Rail Central:

Phase 2a:

Localised Consultation –
plans pack for consultation

Updated draft highways 'red line' plans: the Order Limits A5076 / A5123 / Upton Way roundabout – potential improvements

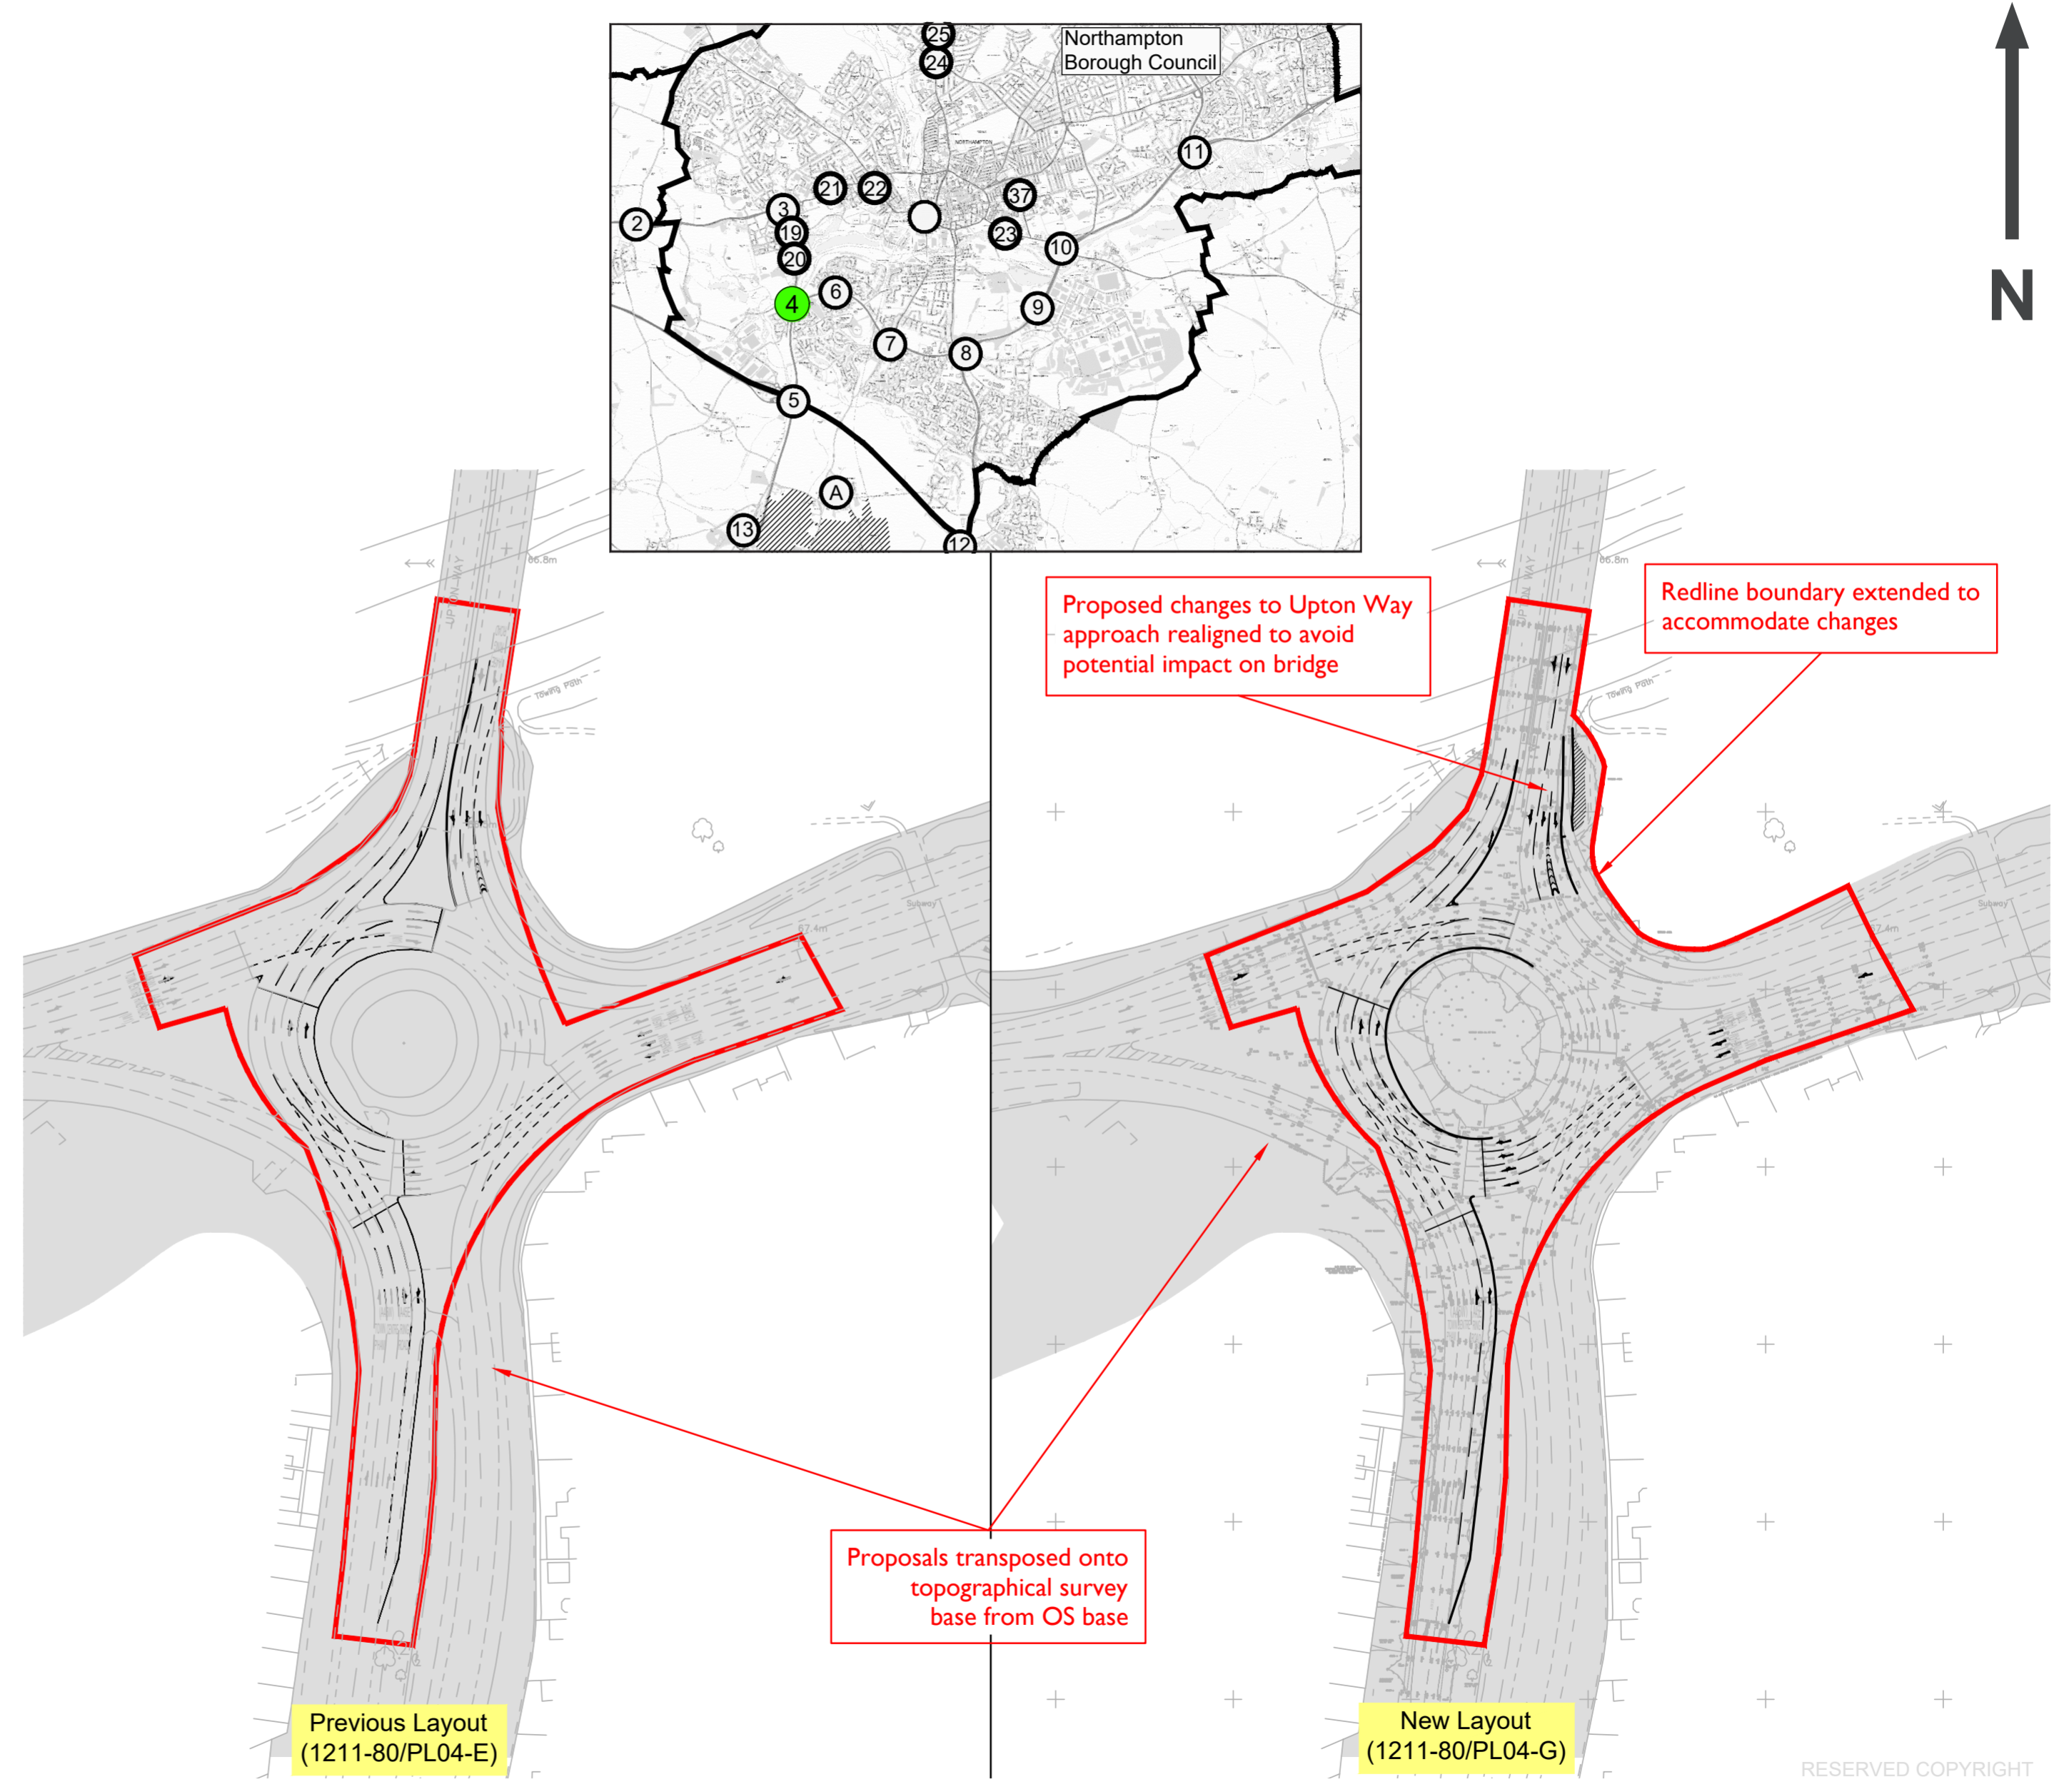
- A5076 / Upton Way: this extension will allow for the approach road and left turn slip lane to be realigned, avoiding any impact on the bridge. The extension will be entirely within existing highway land, owned by Highways England.

Updated draft highways 'red line' plans: the Order Limits A43 / Northampton Road

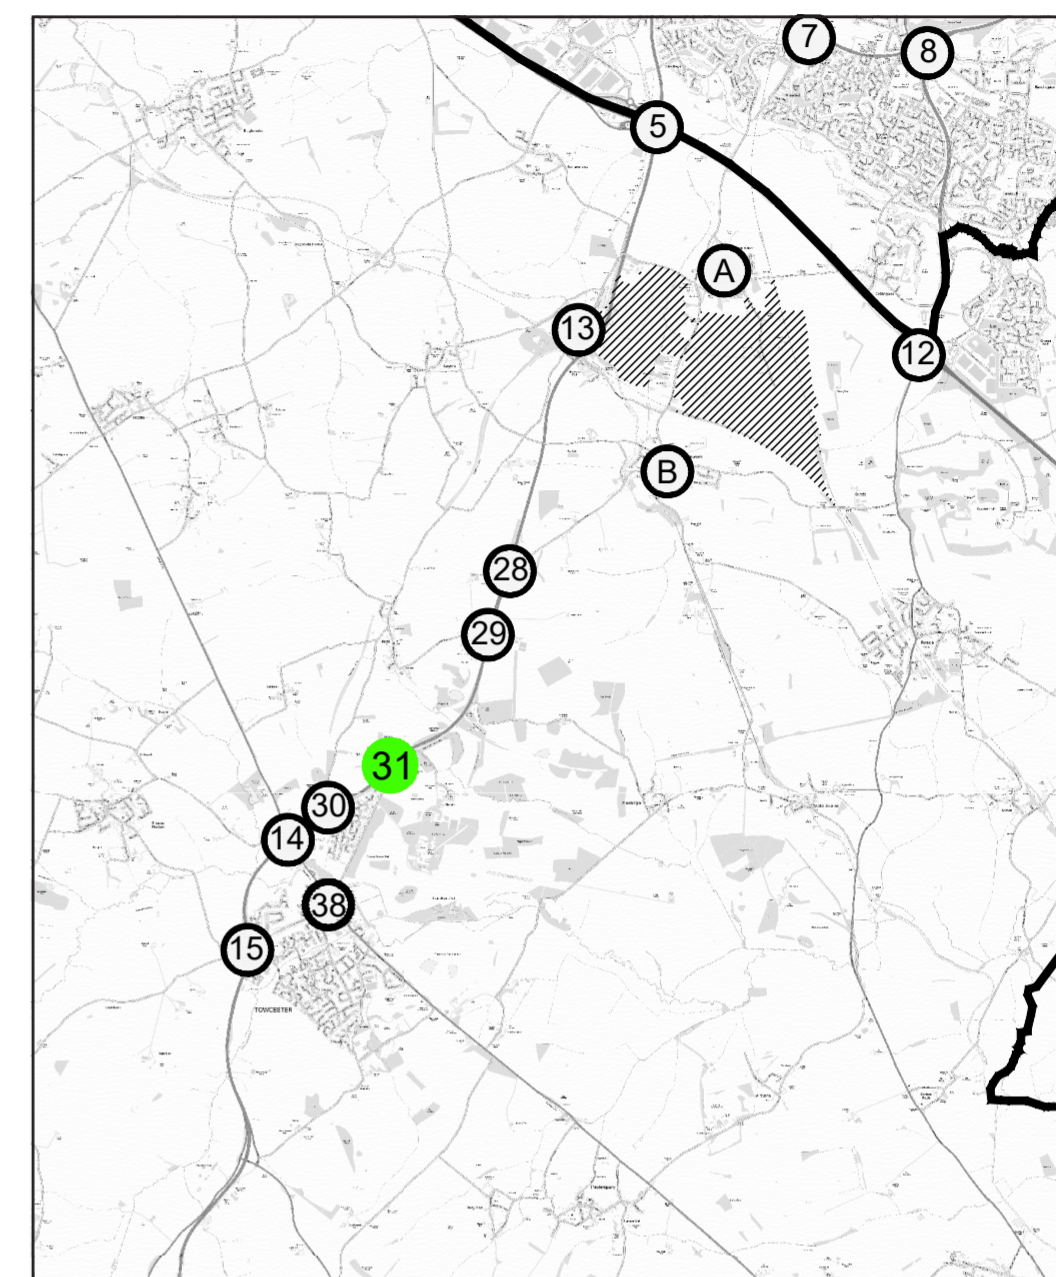
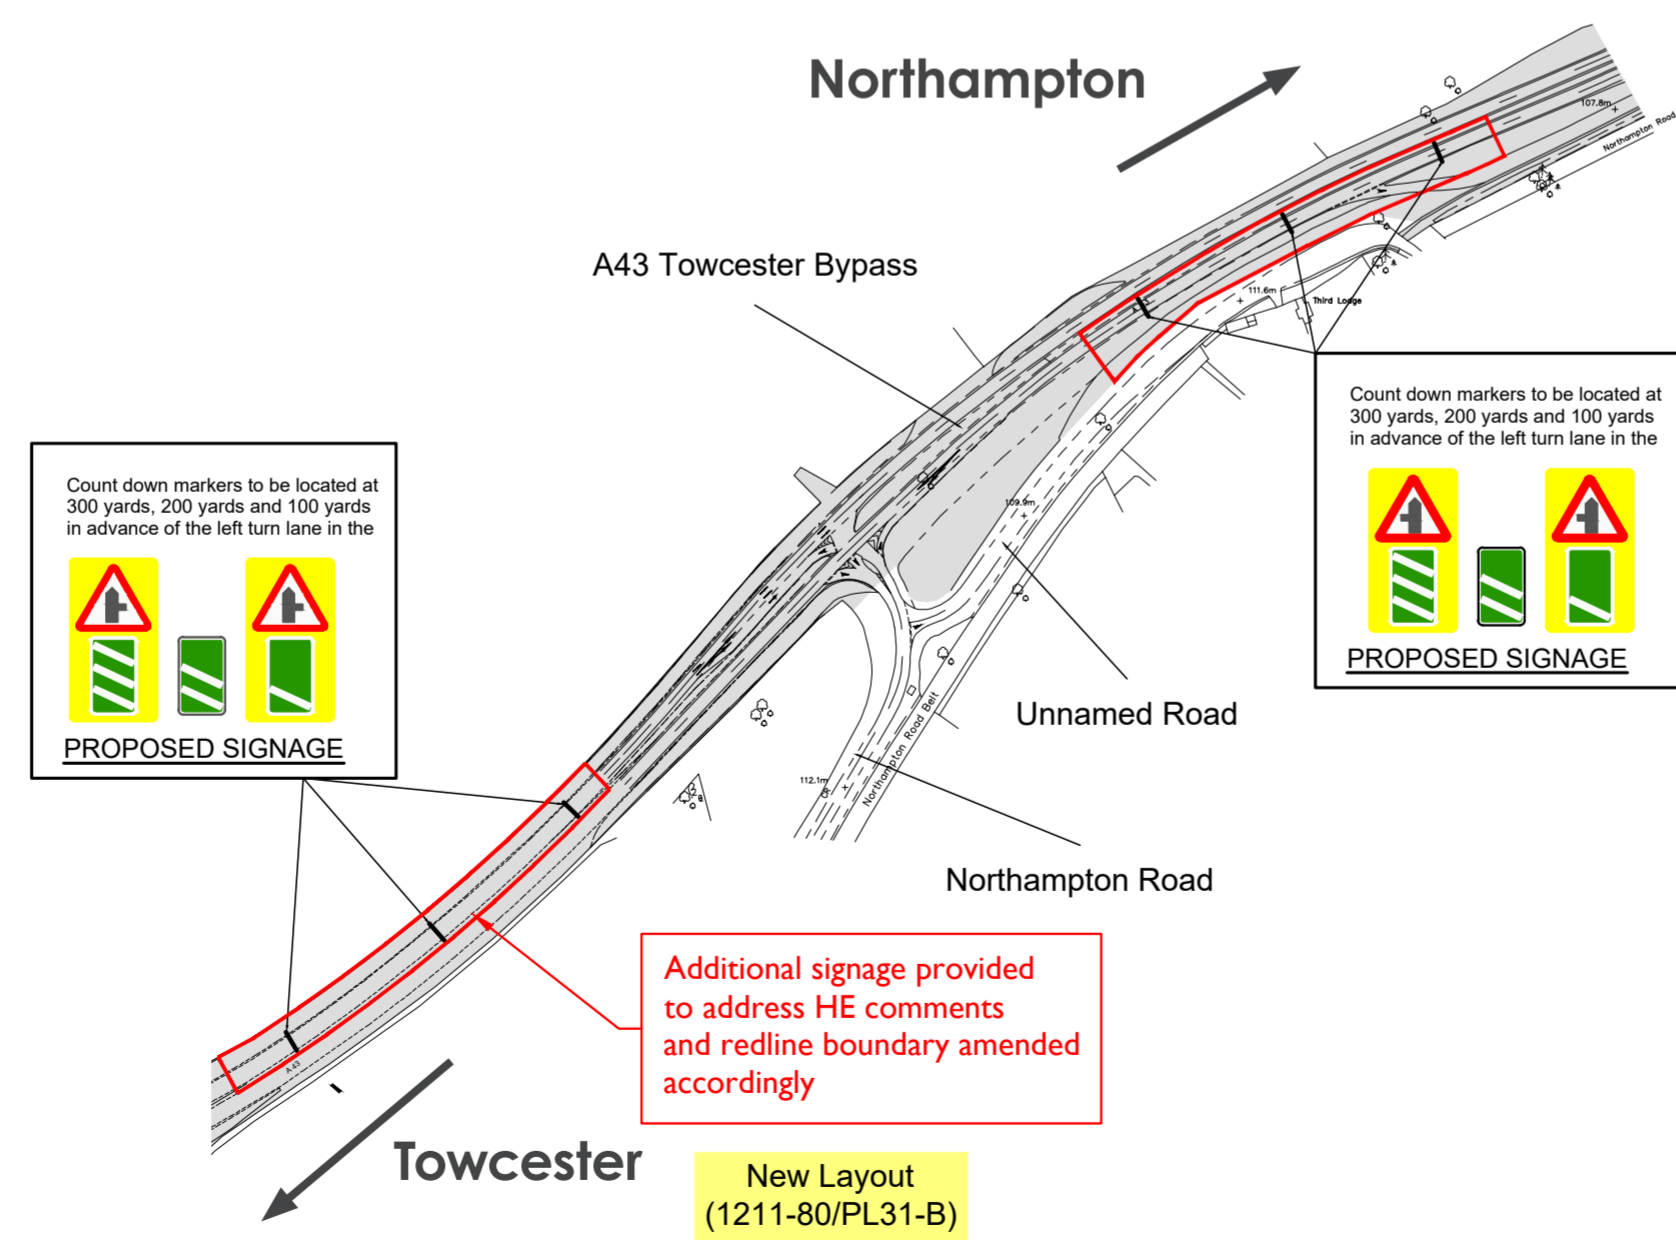
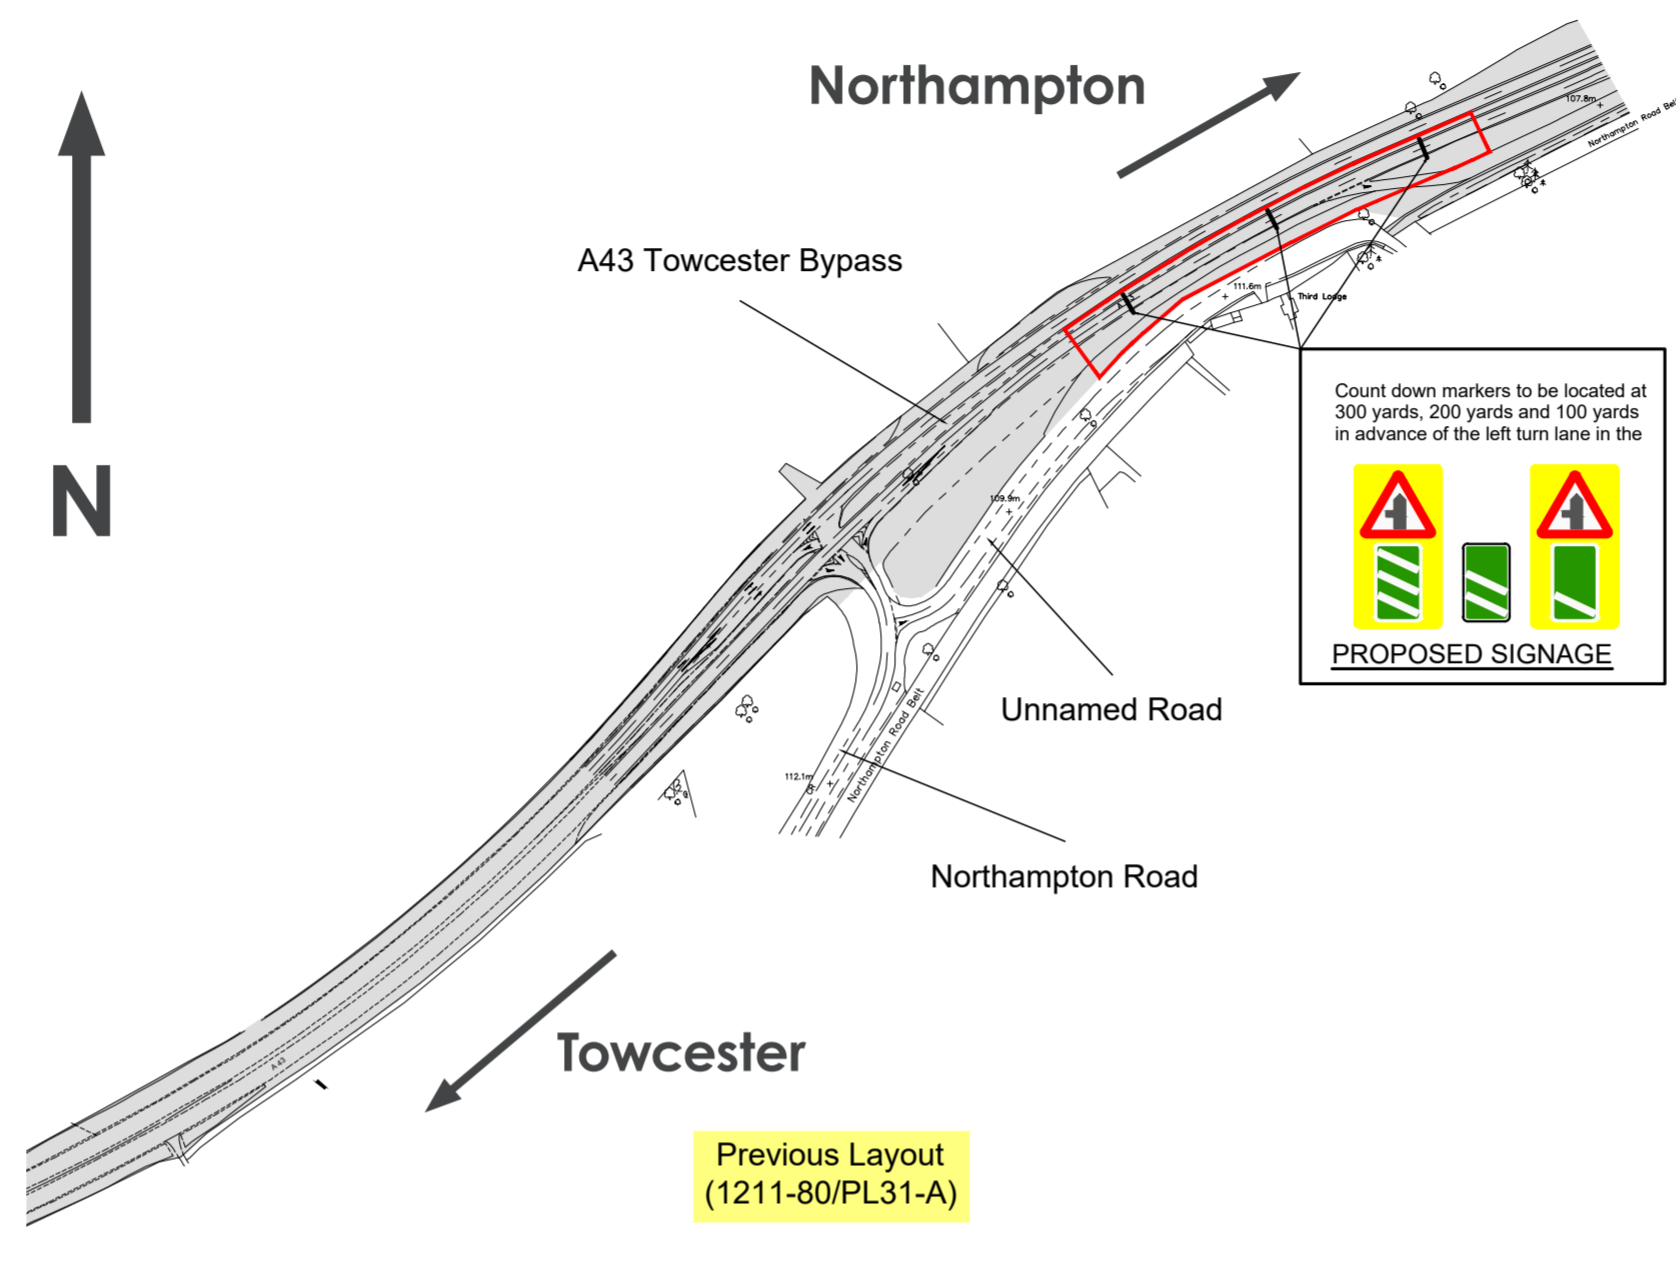
- A43 / Northampton Rd (Safety Scheme): this change is simply the introduction of additional safety signage to the south of the junction. It was prompted by Highways England, which requested that proposed signage should be replicated on both directions;
